#### Regulation No. 44 (Child Restraints Systems)

### **Proposal for draft Supplement 5 to the 04 series of amendments to Regulation No. 44**

#### **Submitted by the expert from Spain \***

"4.8. ISOFIX Marking

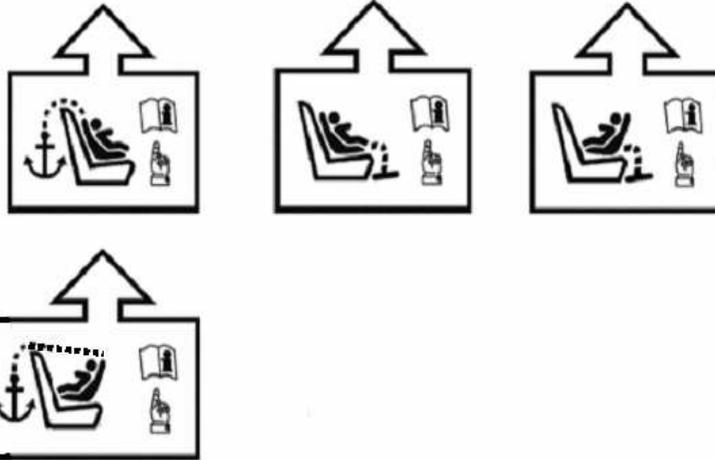
Paragraph 4.8., amend to read:

The current figures do not cover all the possible installation configurations; a fourth figure, covering further installation, already in use on the market, has been added.
